Service Bulletin

S.B. No: 120

Title: INSPECTION OF RUDDER BAR SUPPORT BRACKETS

Applicability: T67B, T67C series, T67M (excluding works no. 1999), T67M-MkII, T67M200, T67M260 and T67M260-T3A.

FIGURE 1
RUDDER PEDAL MECHANISM

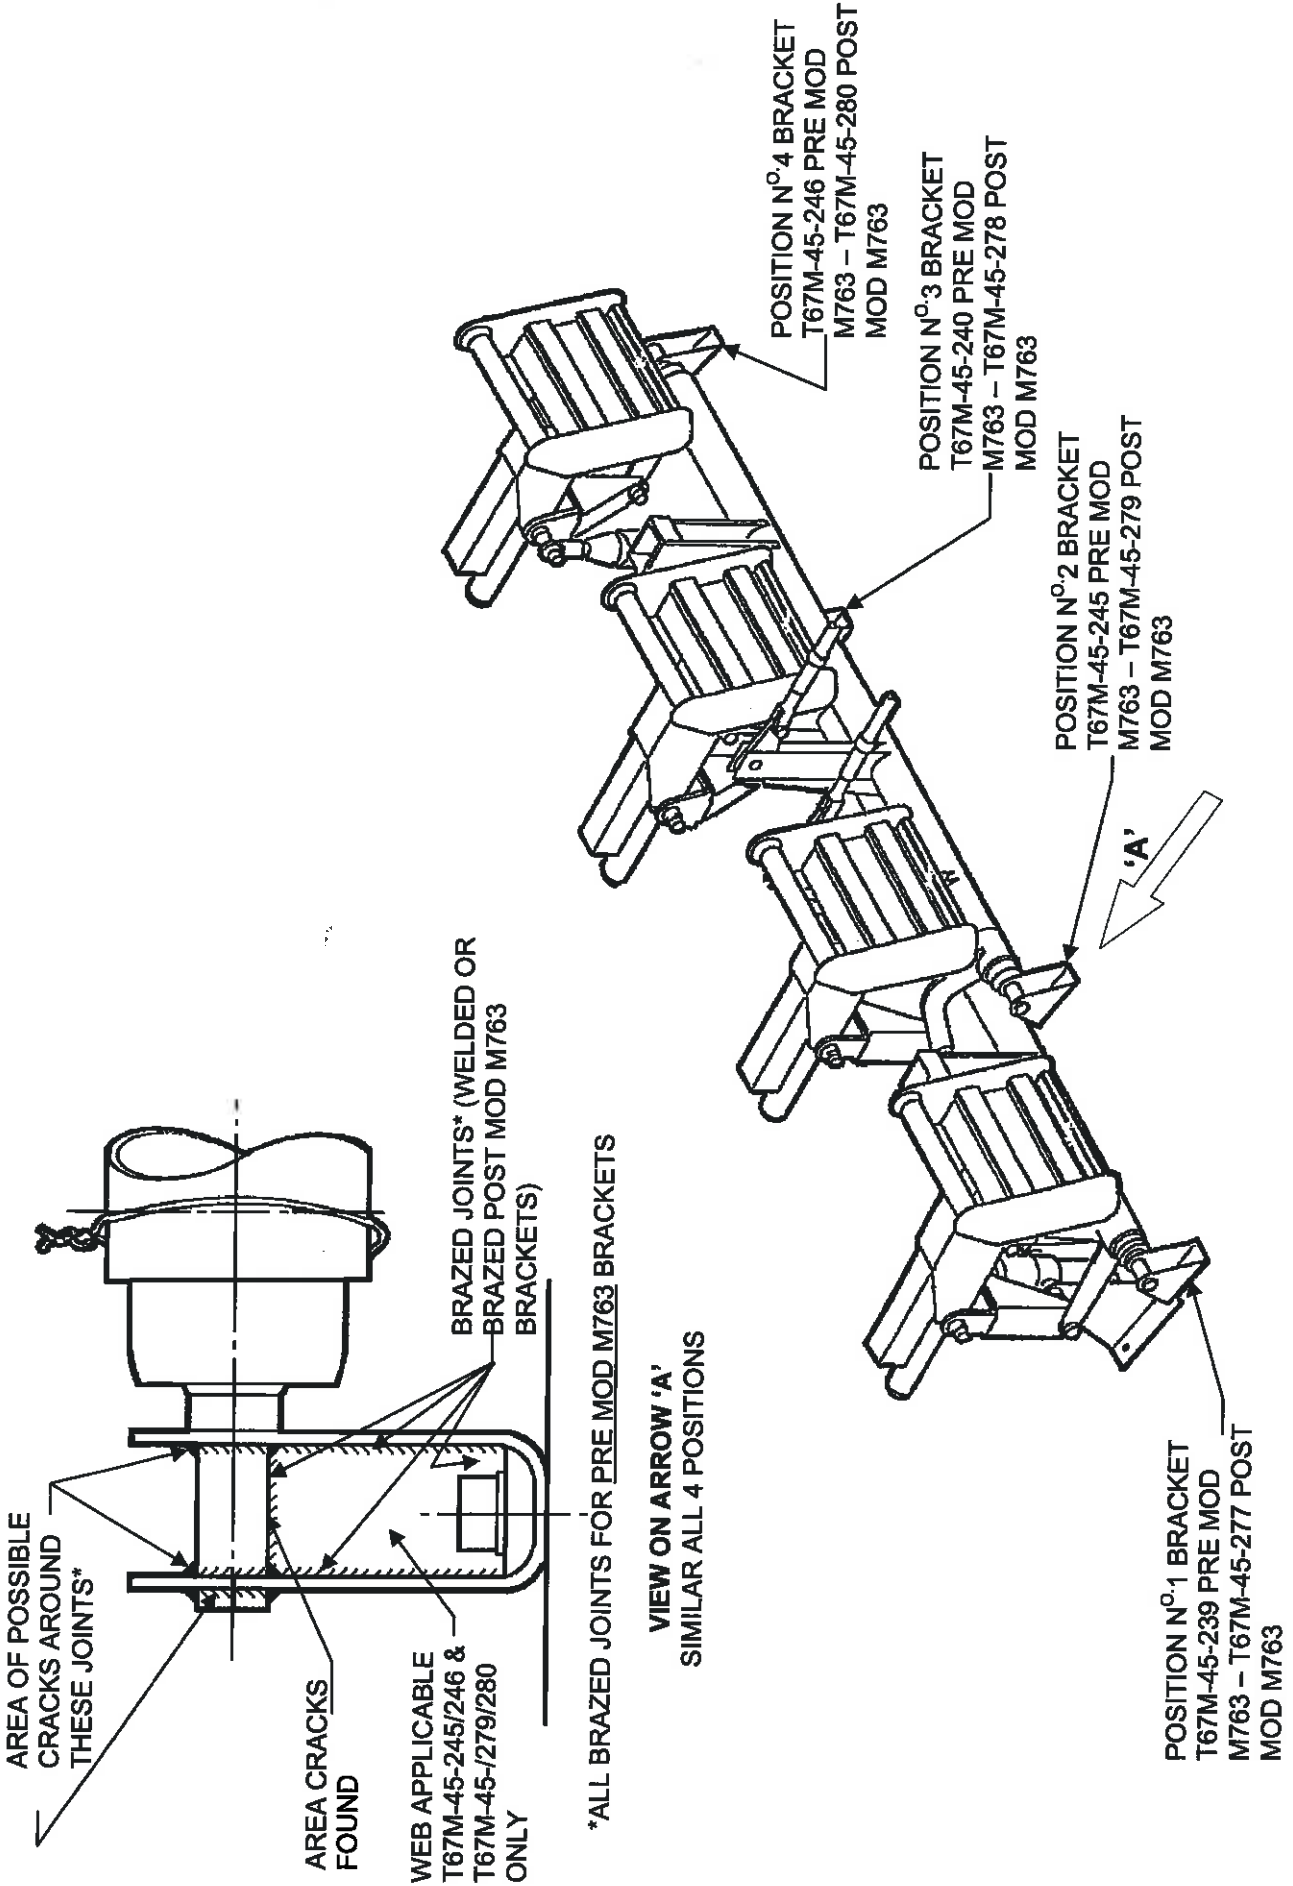
1. Gain access to rudder bar support brackets, refer to Figure 1.
2. Establish whether the brackets are brazed or welded. Recommend removing portion of paint from pin fillets and web fillets. Weld will show as a natural steel colour, brazing as a "brass" colour.

6. Further to actions 2, 3 and 4 inspect both welded and brazed joints for cracking. If cracks found then replace bracket with new item. Refer View on Arrow 'A' Figure 1.

Note: reference T67B, T67C series, T67M (excluding works no. 1999), T67M-MkII, T67M200, (excluding works numbers 2264 & 2265), if brazed bracket is cracked then all four brazed brackets are to be replaced with Post Mod M763 brackets, i.e. T67M-45-277/278/279 & 280, refer Figure 1.
7. Restore paint finish.
8. Annotate logbook inspection carried out and, as applicable, Post Mod M763 brackets fitted.
9. Inspection steps 6 & 8 at each Annual in conjunction with SB 187 & SB 188 (latest issue) as applicable.

3. Should T67M260 series and T67M200 works numbers 2264 & 2265 aircraft have brackets fitted with all fillets brazed then these are to be removed and replaced with Post Mod M763 brackets T67M-45-277/278/279 & 280 as applicable. Note it is acceptable for the pin to be welded and web to be brazed.

4. If Post Mod M763 brackets have been fitted to T67B, T67C series, T67M (excluding works no. 1999), T67M-MkII and T67M200, (excluding works numbers 2264 & 2265), and on inspection found to be all brazed then they are to be re-identified as T67M-45-239/240/245 & 246 as applicable. Ensure Logbook is modified to delete Mod M763.

5. Check brackets T67M-45-277/278/279 & 280 in stores IAW Step 2, if entirely brazed and if brackets are intended for use on the T67M260 series and T67M200 works numbers 2264 & 2265 then these items are to be returned to SAACL. If these items are brazed and are intended for use on the T67B, T67C series, T67M (excluding works no. 1999), T67M-MkII, T67M200, (excluding works numbers 2264 & 2265) series Firefly then re-identify as T67M-45-239/240/245 & 246, refer Figure 1
